Project	IEEE 802.16 Broadband Wireless Access Working Group < <a href="http://ieee802.org/16">http://ieee802.org/16</a> >
Title	Extension of collaborative spatial multiplexing in OFDMA
Date Submitted	2004-11-12
Source(s)	Bin-Chul Ihm, Yongseok Jin, Jinyoung Chun, Voice: 82-31-450-7187 Kyuhyuk Chung Fax: 82-31-450-7912  LG Electronics, Inc. <a href="mailto:{bcihm, jayjay, jy Chun03, kyuhyuk}@lge.com">[mailto: {bcihm, jayjay, jy Chun03, kyuhyuk} @lge.com]</a> 533, Hogye-1dong, Dongan-gu, Anyang-shi, Kyongki-do, Korea
Re:	This is a response to a Call for Comments on IEEE P802.16e-D5
Abstract	The collaborative spatial multiplexing can be applied to the case in OFDMA.
Purpose	This document is submitted for review by 802.16e Working Group members
Notice	This document has been prepared to assist IEEE 802.16. It is offered as a basis for discussion and is not binding on the contributing individual(s) or organization(s). The material in this document is subject to change in form and content after further study. The contributor(s) reserve(s) the right to add, amend or withdraw material contained herein.

# Extension of Collaborative Spatial Multiplexing in OFDMA

Figure yyy – MIMO tile in UL PUSC mode

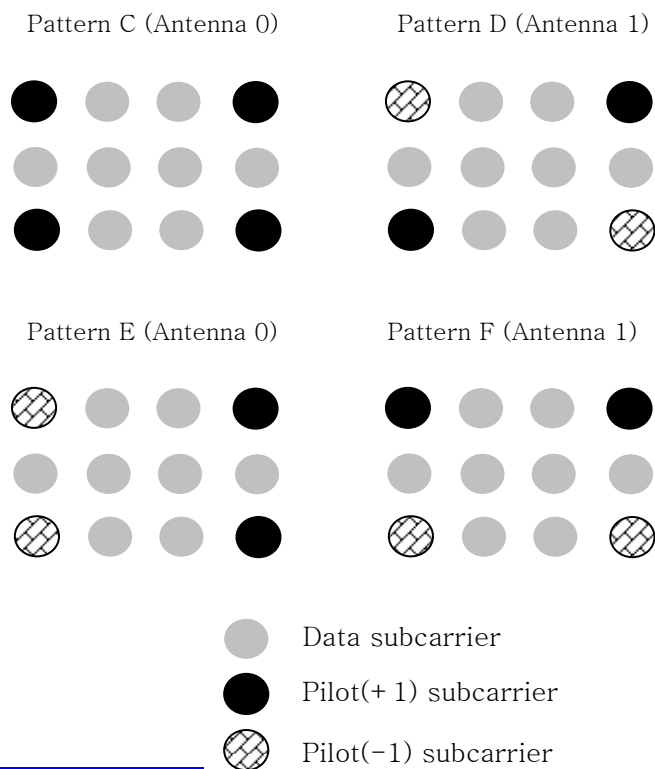
8.4.8.1.5.1 Uplink using enhanced STC

A user supporting transmission using STC configuration in the uplink, shall use a modified uplink tile, 2-transmit diversity data or 2-transmit spatial multiplexing data can be mapped onto each subcarrier, the mandatory tile shall be modified to accommodate those configurations. Figure yyy depicts the UL tiles for enhanced STC transmission in PUSC mode.

Two SS's of one or two transmission antenna can perform collaborative spatial multiplexing onto the same subchannel. In this case, each SS should use the uplink tile with the pilot pattern indicated in MIMO\_UL\_Enhanced\_IE. A dual transmit antenna SS can use the allocation in STTD, SM or collaborative SM mode with other SS. SS in collaborative SM mode with dual transmit antenna sends data in ordinary STC configurations as in section 8.4.8.1.4 using the pilot pattern pair indicated in MIMO\_UL\_Enhanced\_IE. The first pilot pattern in each pair is for antenna 0 and the second is for antenna 1.
